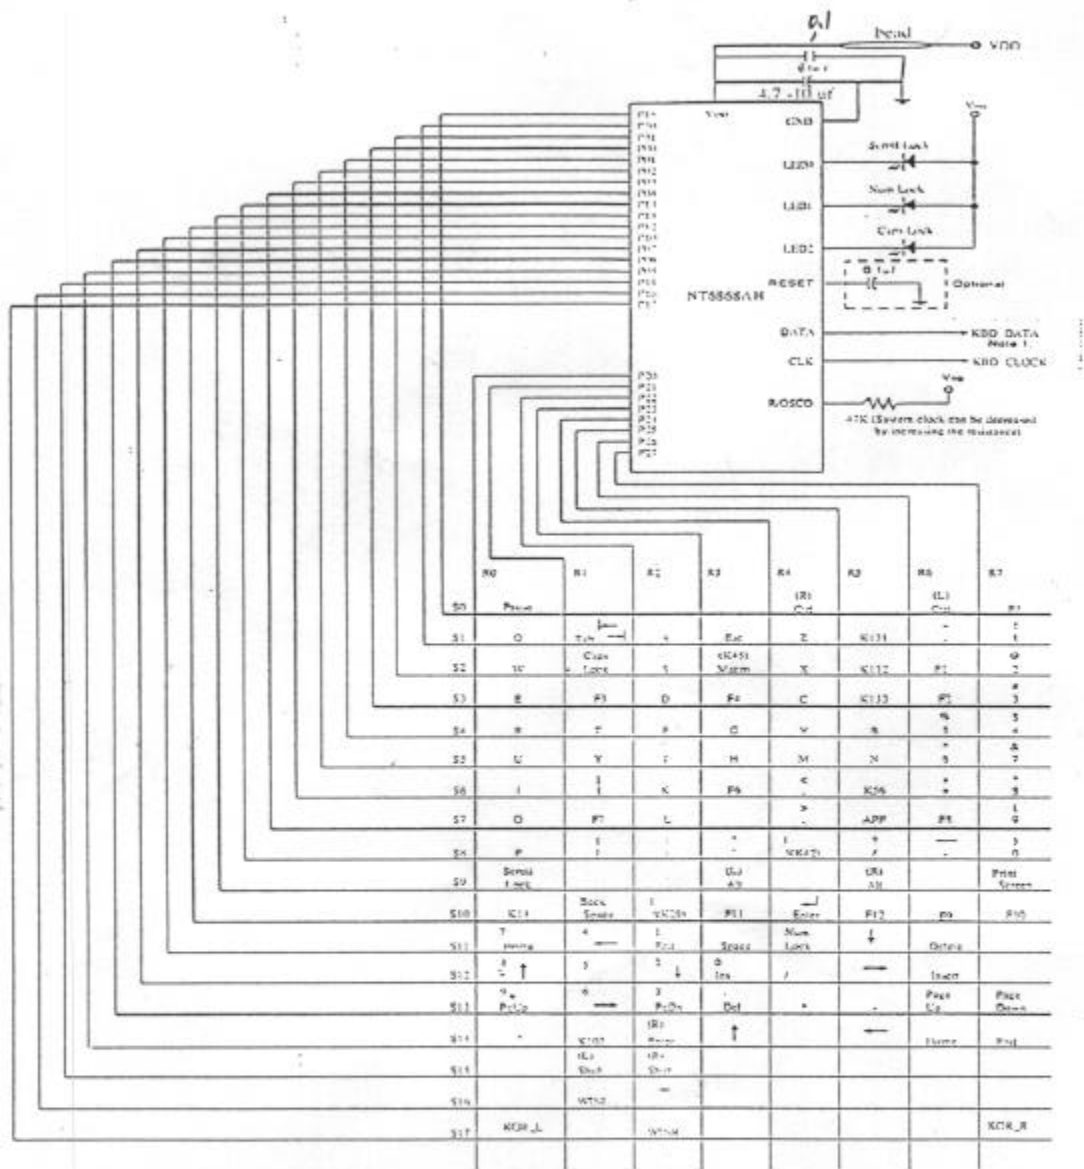
Note 1: For FCC approve, please add an rgn type of bead for the signal wire can go through inside of the bead.
